# Indian Electricity Grid Code Revision: Suggestions for technical requirements for wind, solar and storage

Presented to 'Expert Group on Grid Code Review' on 7<sup>th</sup> Sept 2019 in CERC office, Delhi

Dr. Pukhraj Singh Head of Segment, Electrical and Electronics Design, Suzlon Energy Ltd | German Branch, Rostock, Germany

# High Voltage Ride Through (wind, solar, storage)

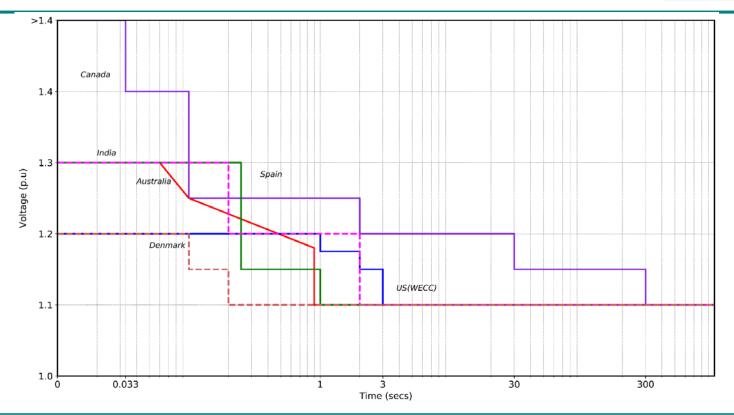
Suggest to limit HVRT upto 120%

- Over voltage should be limited up to 120% at the point of connection as the grid will be further strengthened and regulated
- Testing of wind farm at point of connection not possible
- Suggest to define performance during over voltage condition (active power, reactive power, response time)
- Suggest to issue guidelines to define compliance through simulation before commissioning
- Prove compliance with real fault post commissioning and allow fine tuning of parameters

# Low Voltage Ride Through (Wind, Solar, Storage)

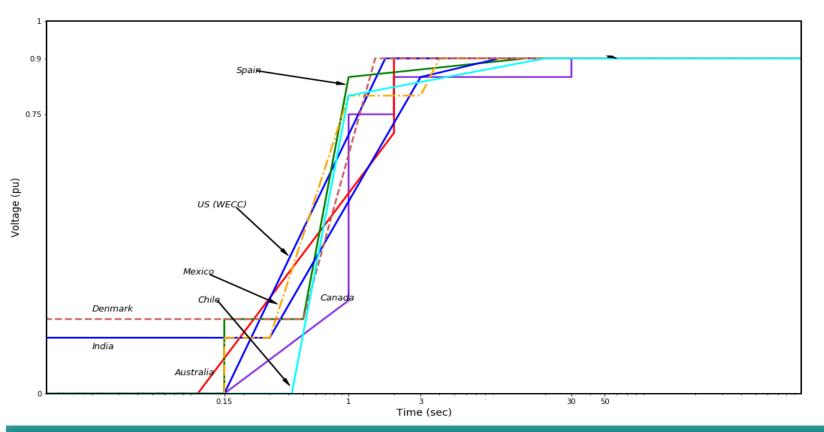
Standard requirement with varied performance

- LVRT Testing of wind farm at point of connection not possible
- To be adapted according to voltage level at connection point
- Define performance during low voltage condition (magnitude of active power & reactive power)
- Compliance through simulation before commissioning of wind farm,
- Prove compliance with real fault post commissioning and allow fine tuning of parameters

# **Performance during Fault Ride Through**

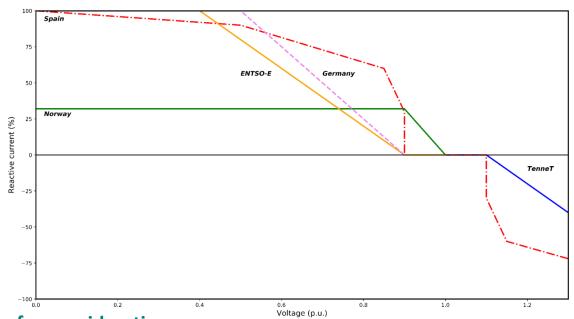
Suggest to define magnitude of reactive current injection/absorption

- 1. Wind and solar park to operate in inductive power factor mode above 1pu Voltage
- 2. Above 1.1pu Voltage, feed inductive current proportional to voltage rise
- To support grid voltage stability
- state of art Wind, Solar and storage converters capable to meet these requirements
- We should define how Wind and Solar generators should behave considering Indian grid protection and operation philosophy and not according to certification agencies

### **Grid frequency Events less than 49.7Hz**

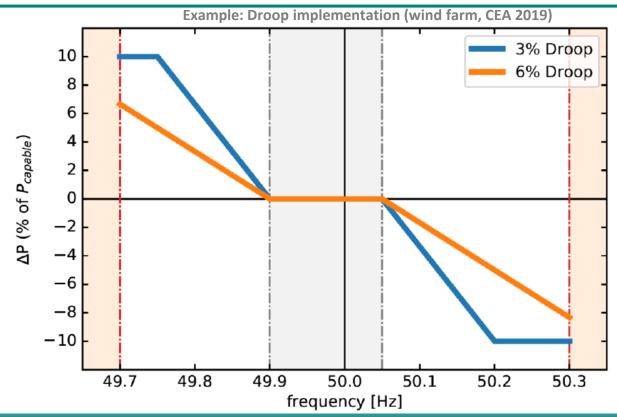
- Frequency deviations >0.3 Hz could range from few second to several minutes
- Suggest duration of fast frequency response of 5 minutes duration commensurate to wind speed or solar insolation
- Fast frequency response of various duration (based capability of RE parks) should be considered as separate Ancillary Service and suitable commercial mechanism to compensate for this service to be provided

# **Grid Frequency Regulation as Ancillary Service**

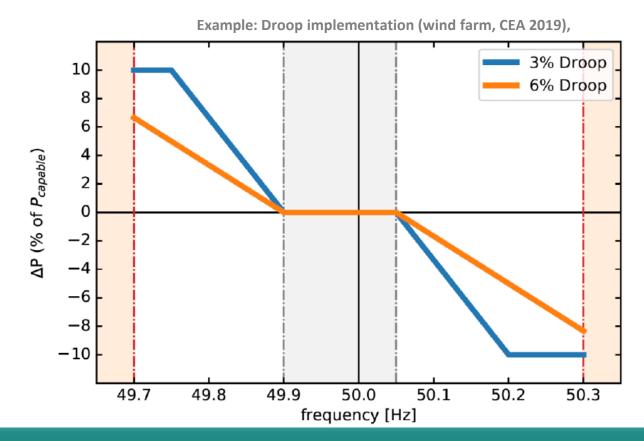
- Over frequency response from wind and solar technically possible
- Should not be used for normal frequency regulation, but only in case of contingency
- A detailed technical description with accuracy, response, curve should be provided to have uniform regulation characteristics
- Should be applicable at PCC and not at generating unit

# **Synthetic Inertia as Ancillary Service**

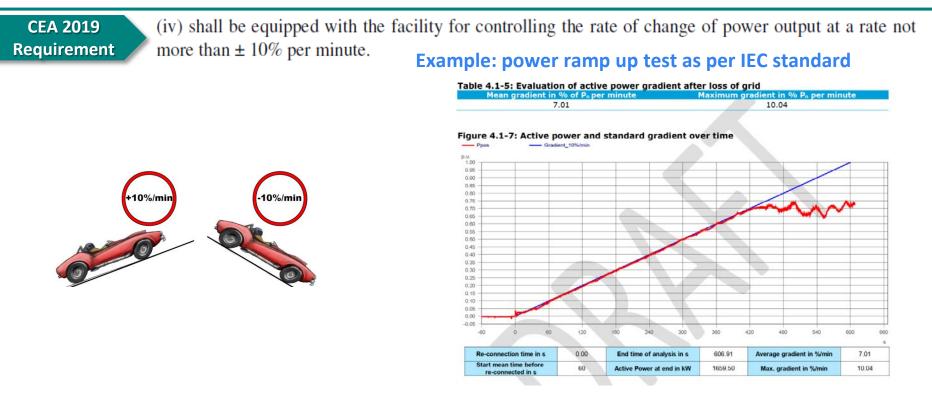
Suggested to incoprpare if RE penetration expected to be very significant

- The medium to large sized RE plants should provide frequency stability capability through synthetic inertia/fast frequency response during very fast grid frequency deviations.
- This feature could help to arrest rate of change of frequency.
- The applicability of this technical capability and performance parameters should be specified considering real benefits and associated costs by SLDC, the grid operator should make contract with plant owner to deliver this ancillary service.

### Harmonic current from RE Generating Station

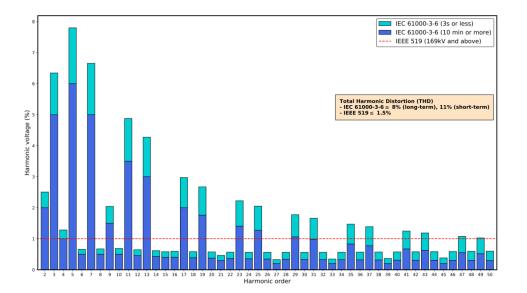
#### Suggest IEGC to define limits at generating station level

Harmonic emission limits should be defined based on PCC strength, size of park, voltage level

The harmonic emission evaluation method and acceptance criterion should be defined either using IEC or CIGRE or any other defined method
